To: Doug Buskirk, Doug Pack	
From: Brad Hyre, Joanne Shaner	Project: SCI-823-0.00
CC:	
Date: 12/12/12	Job No: 189559

RE: R/W needed for crane movements and access to site during construction – SR 823 over CSX and SR 823 over Little Scioto River

RAILROAD IMPACTS

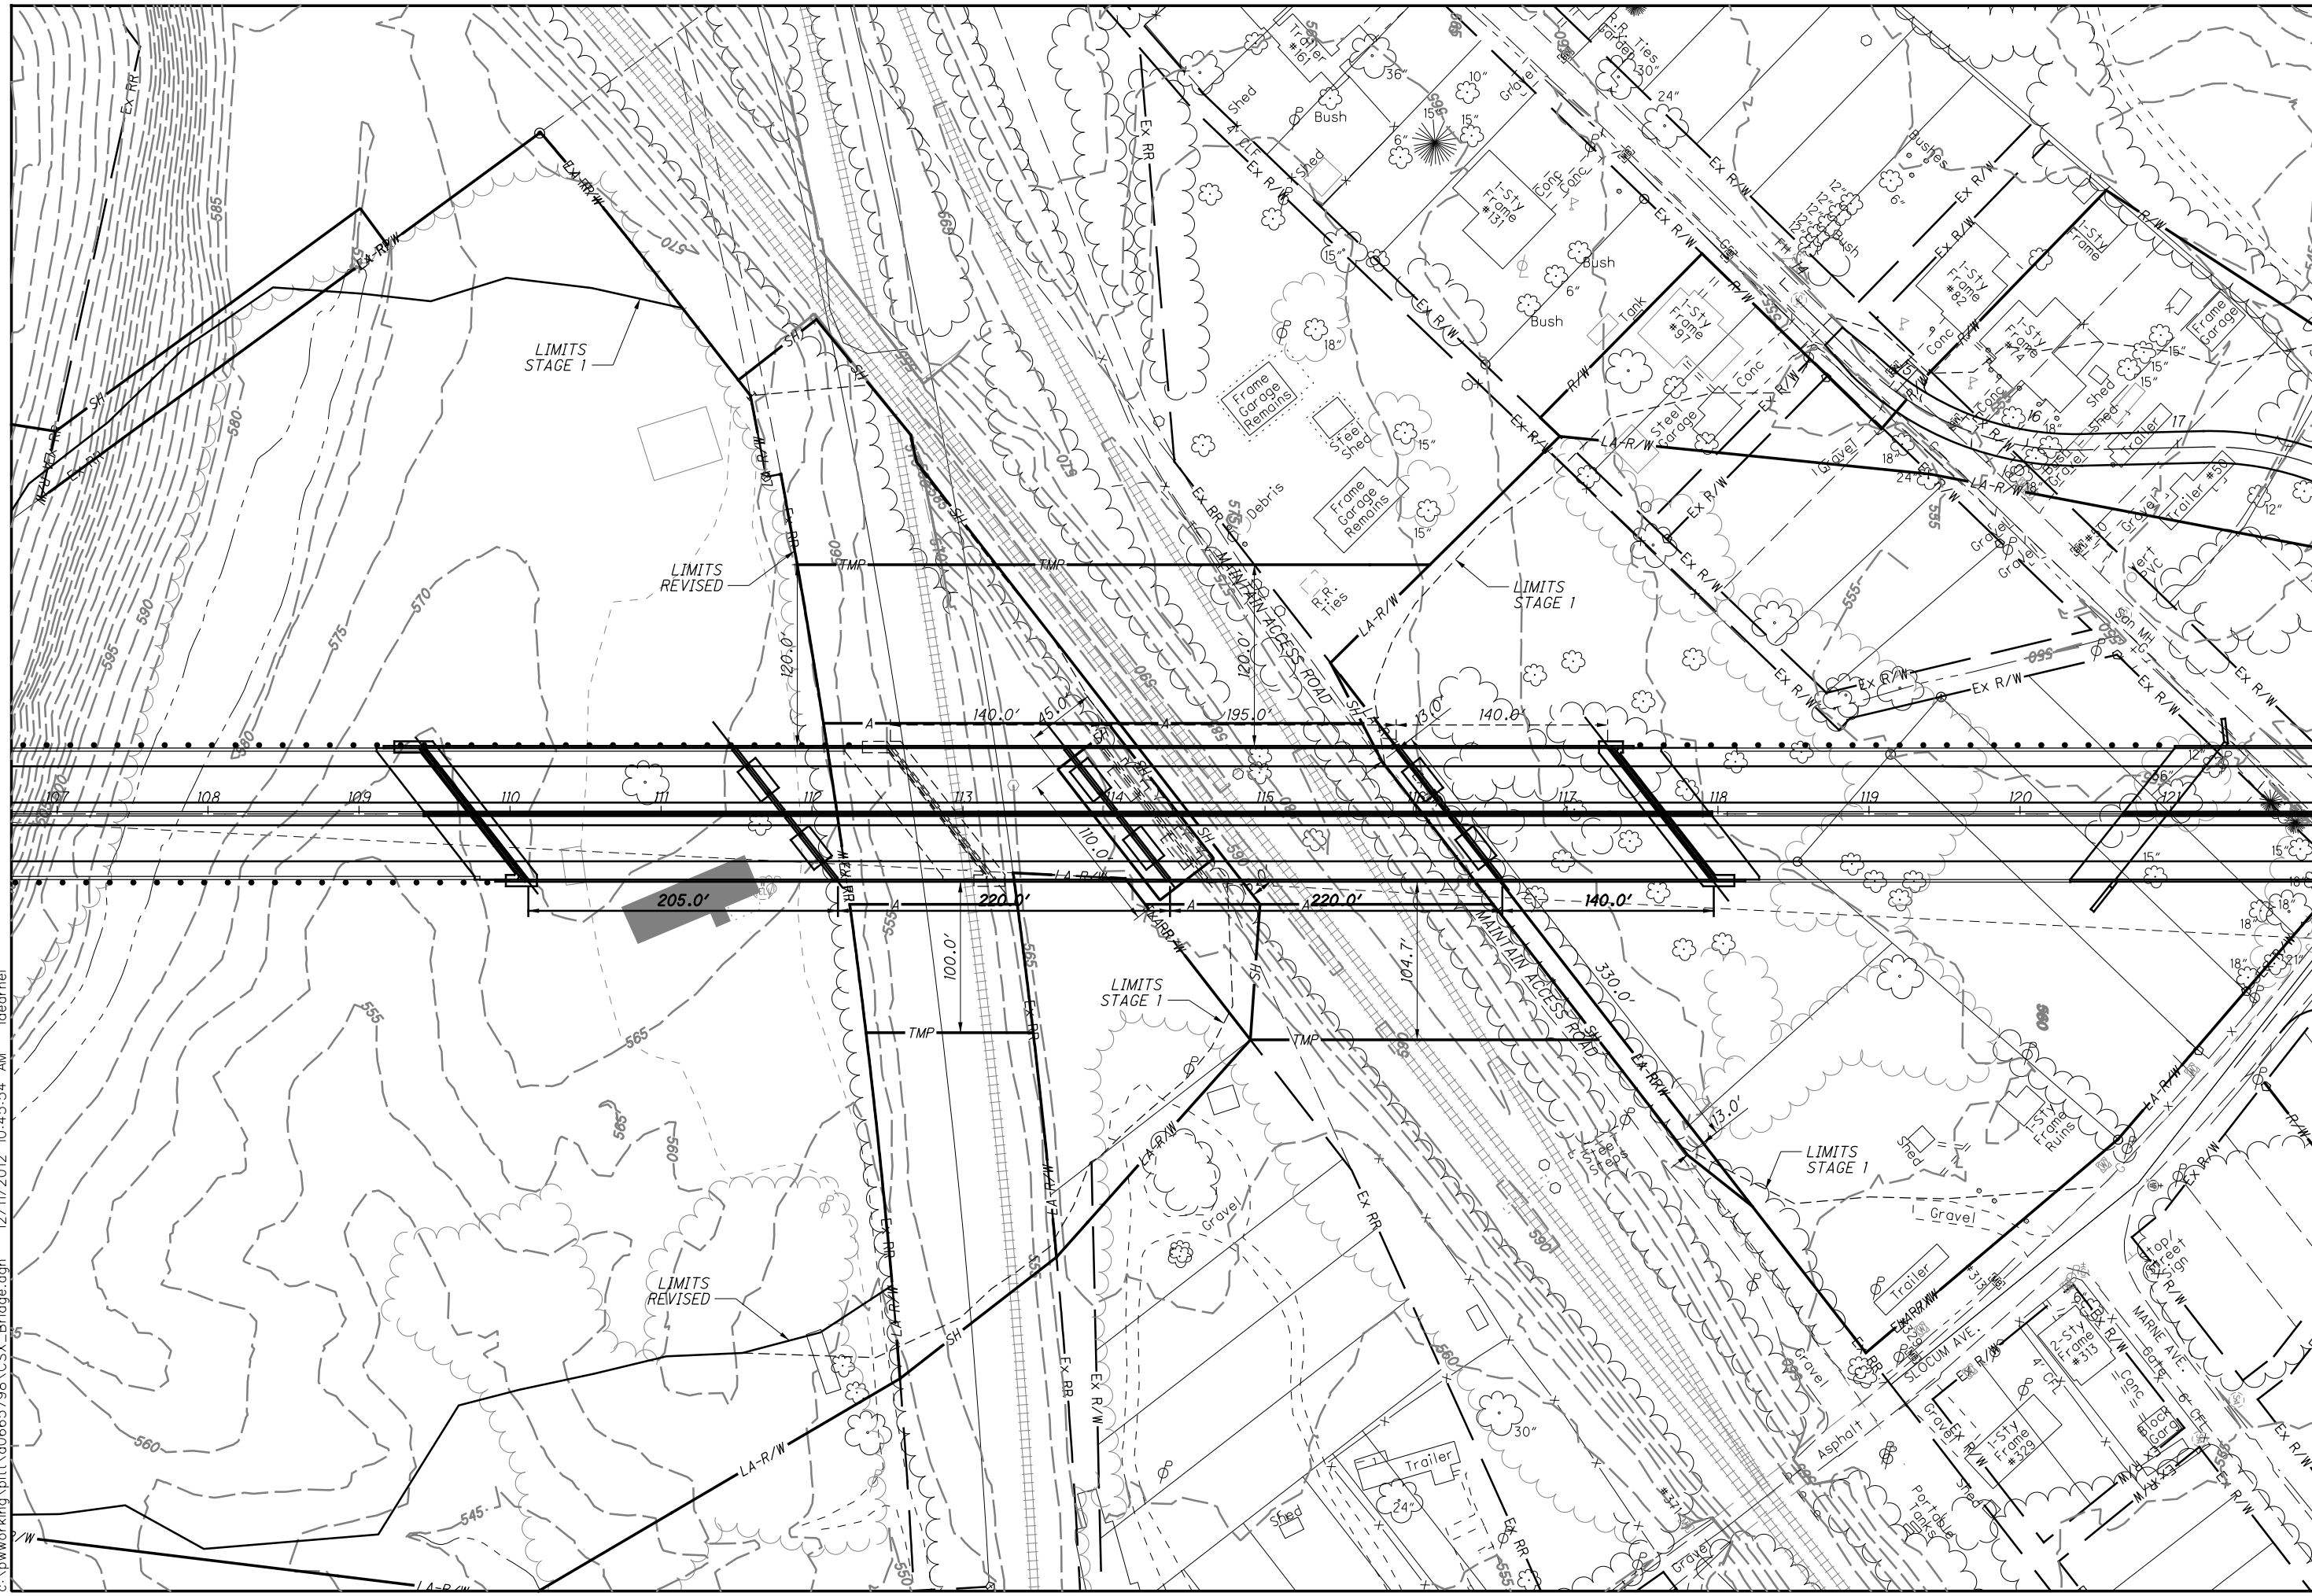
Two possible span arrangements were used for estimating girder lengths; the three-span option shown in the Stage 1 plans and a four-span structure which spans the abandoned track south of the CSX tracks. Lengths of the girders were assumed to be a maximum of 120'-125' based on recommendations from an erector after review of the girder depth and span arrangements. Girder weight was estimated using the Stage 1 plans and approximating the flange sizes using AASHTO guidelines.

For the four-span structure, the proposed right of way limits shown on the exhibit appear to be sufficient for erection at the rear abutment and pier 1. Portions of the new embankment will likely have to be removed so as to provide access for the crane and trucks. A 15% grade would likely be the maximum possible for the access road which may lead to the need for a switchback type of access road. Preferred grade is 10%. Width of access road would likely be 30'-40'. It appears this can be done within the proposed limits. However, access to the site via the abandoned railroad line may be necessary at this location. It is anticipated the site will be accessed by entering along the abandoned railroad line and then building the access road back toward the rear abutment. It is recommended the agreement with the railroad include the use of the abandoned railroad for access to site.

For the three-span structure, as with the four-span structure, portions of the new embankment will likely have to be removed so as to provide access for the crane and trucks. For this option, the right of way is expected to include a standard highway easement. It appears the access road, with similar grade and width as the four-span option, will be able to be constructed within the standard highway easement shown. Access to the site via the abandoned railroad line will likely be the most feasible options.

For both span arrangements, there is a need for a railroad agreement to work over and within their right of way to set the span over the active tracks. In addition, a crawler crane is required due to the size of the crane needed for the assumed weights of the girders. The crawler crane must be assembled on site. Therefore, the work area for the crane must be large enough for the delivery trucks to access and for the assembling of the crane. Hence the need for the larger areas at the Northwest and Southeast corners of the active tracks where crossing beneath the bridge.

A 50-100' width will need to be provided on either side of the structure to allow for the girder transport truck and crane. The 50' was estimated as a minimum with the 100' limit being the preferred. This limit is shown on both sides of the structure as a worse case scenario. With the heavy skew, it may or may not be possible to set the girders from one side of the structure. Limiting the R/W to one side would limit the means and methods of the contractor. Therefore, it is recommended the R/W be shown on both sides of the proposed structure.
